Schematic

DISCLAIMER - Calculations & Drawings
Belong to the previous group! as we
are checking & Modifying their design.

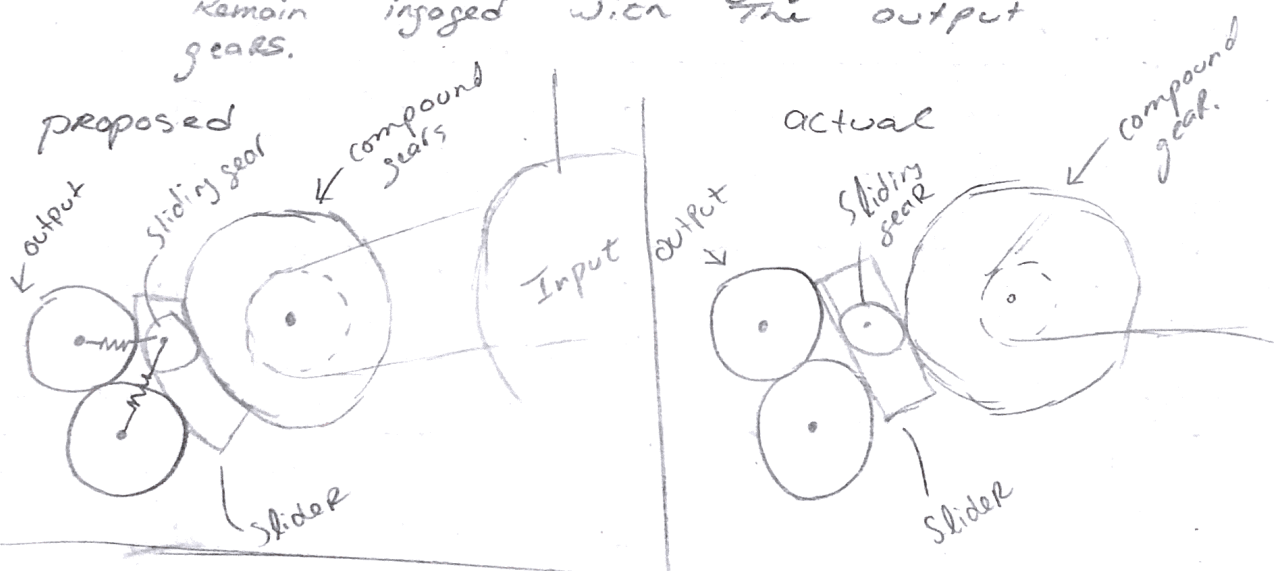
As we worked through the calculations from previous group we all arrived at the conclusion that the calculation was correct. But The Schematic that is shown is not one that matches the actual design of the gear Box its self. The Slider in which the sliding gear is curved in the Schematic, which allows for the gear to stay in constant contact with the output gear.

However The Actual Gear in the Bike is on a horizontal axis only in the X-plane. Which does not allow for enough force for constant contact when a load/input is applied.

AS you can see the area of contact between the actual and the proposed is significantly different. Causing slippage in the sliding gear. By fixing the slider and adding possible tensioners we believe the slippage problem is fixed.

The New design consists of a fixed slider & gear. THE NEW gear slider will be curved & have tensioners to allow for the sliding gear to remain engaged with the output gears.
